Design Advisory: No audio output on VocalFusion Stereo Dev Kit for Amazon AVS

Figure 2:
Identifying
date code on
VocalFusion
Stereo Dev
Kit for
Amazon AVS

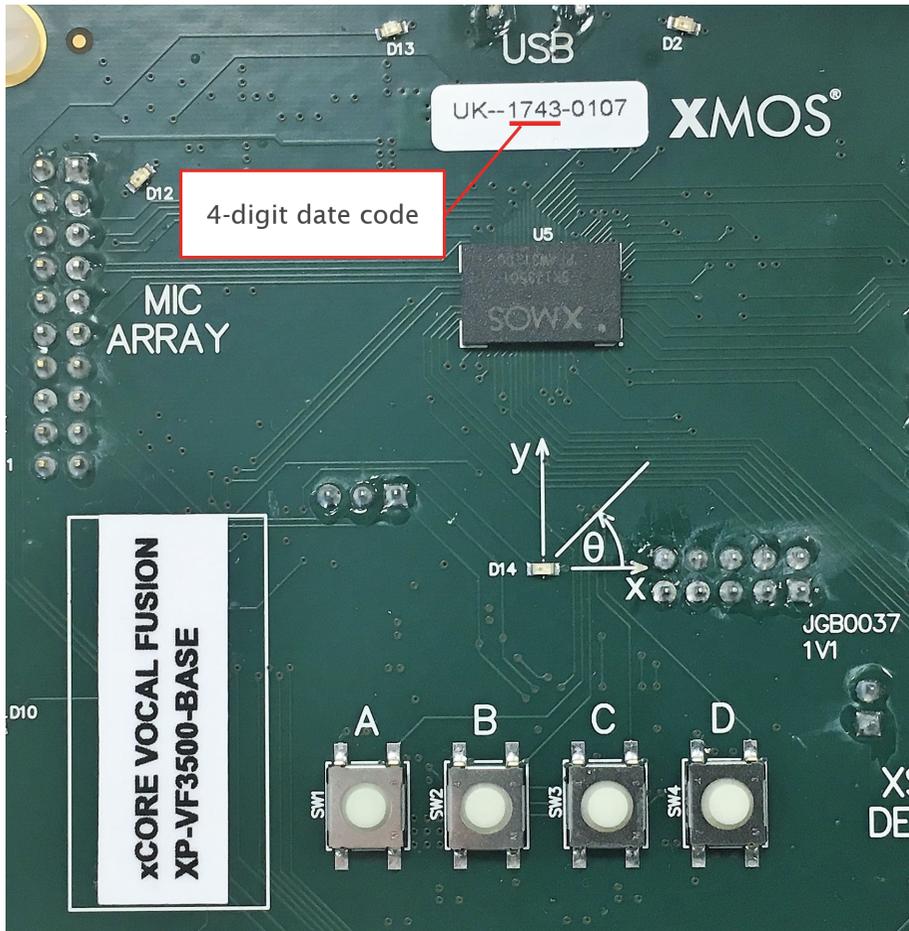
Impacted development kits can be identified from the date code of the XP-VF3500-BASE board: boards with a date code **1806 or earlier** are affected as they are flashed with v2.1.0 or earlier of the VocalFusion software therefore this design advisory applies.

Customers who observe this issue are advised to update the software on the development kit to the latest release (v2.2.0rc7 or higher) which can be downloaded as a zip archive from the XMOS website.
